Subject: Prefontaine Place - tree removals

**Arborist Report
PRELIMINARY**

Site: City Hall Park

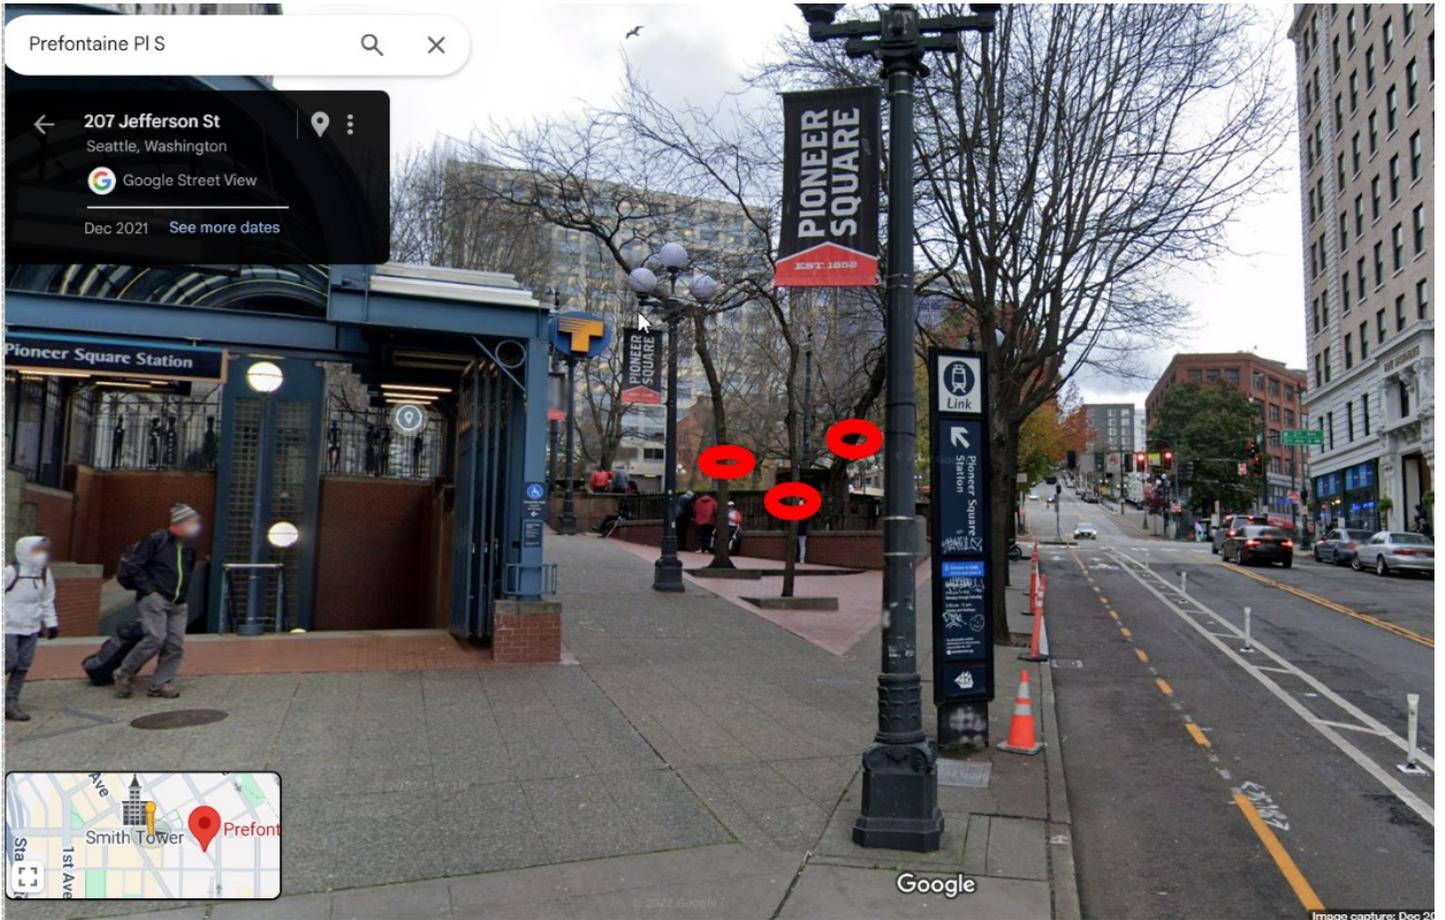
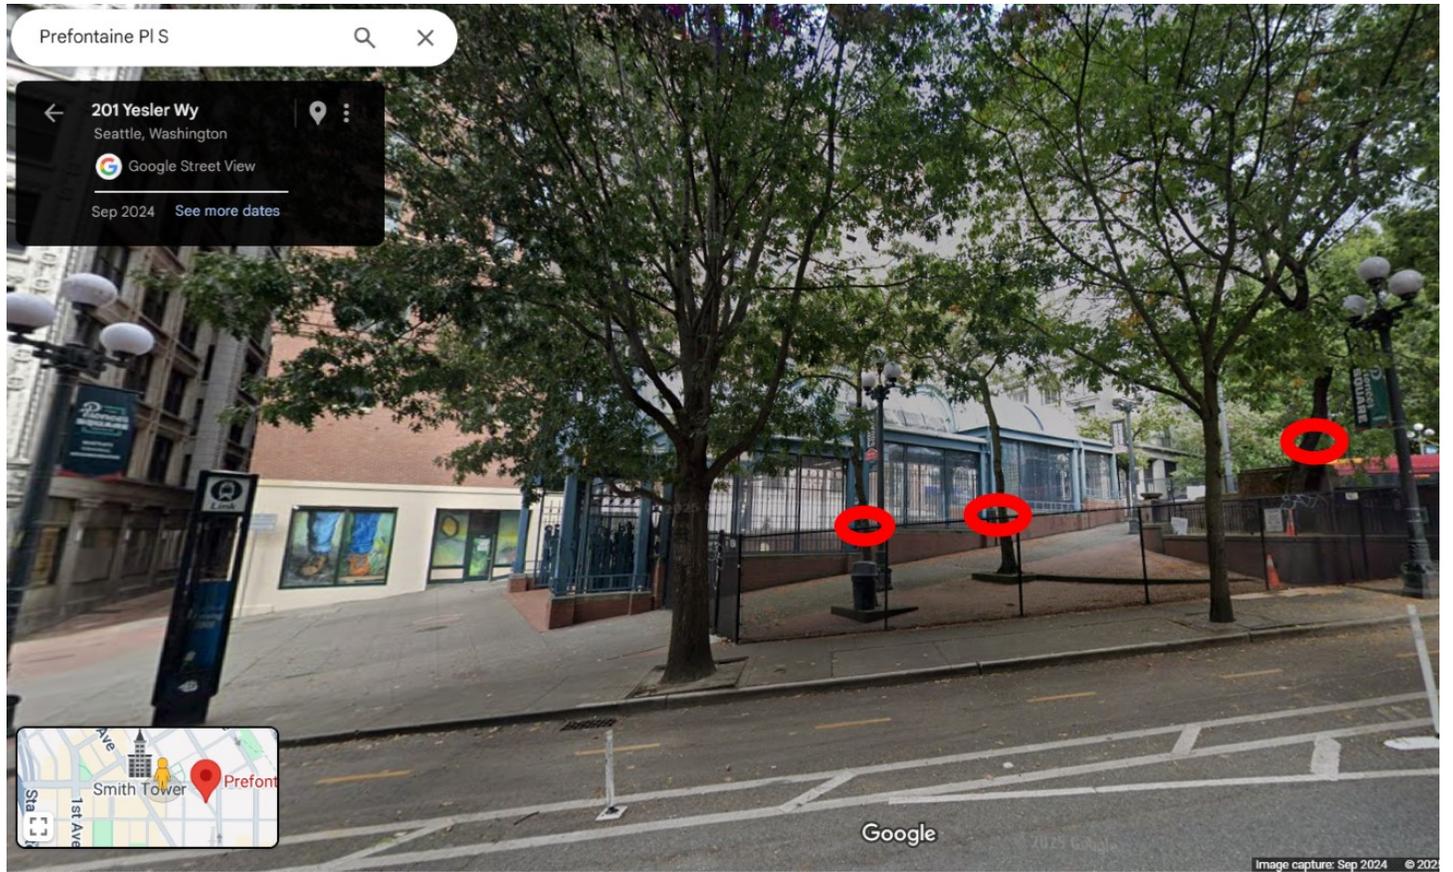
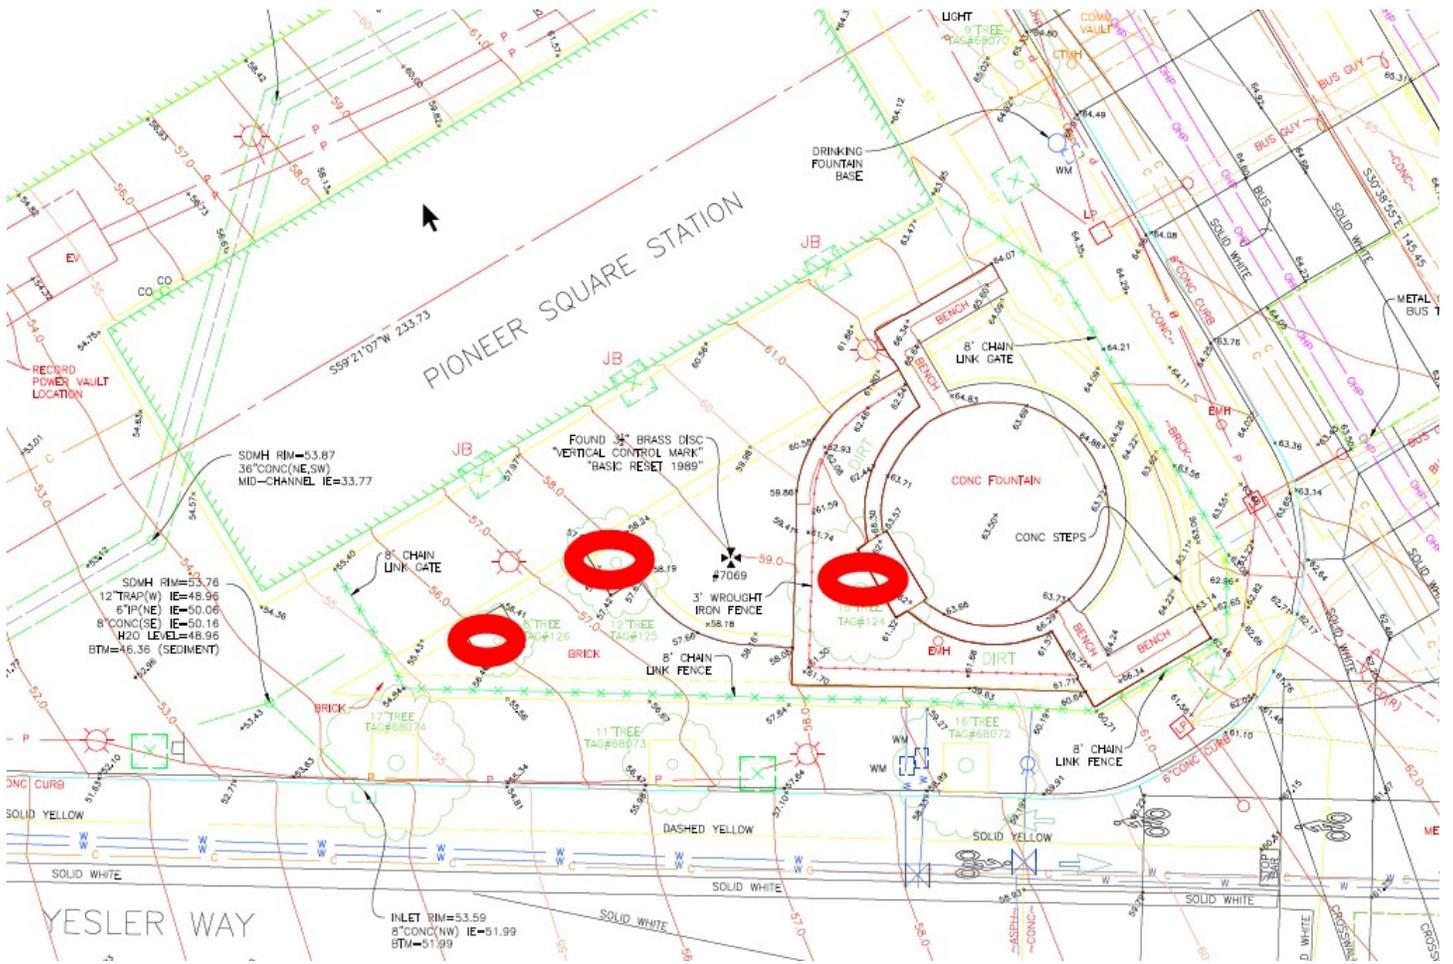
As discussed earlier, we would like to proceed with removing the tree marked with an X, which is the one most leaning. We will compensate for this tree at a 3:1 rate on a site other than Prefontaine TBD. Please confirm this understanding. Thank you!

SPR tree crew is not planning to remove those trees. We prioritize our work based on risk; these are low risk and would need to be removed as part of the design.

We visited this site and with your input determined that the trees signified below with a bold red circle are in fair to poor condition and can be removed. What is the process required to expedite the removals?

Yes, confirmed. Please make sure this is reflected on the plan and the replacement tree locations are provided with the plan.
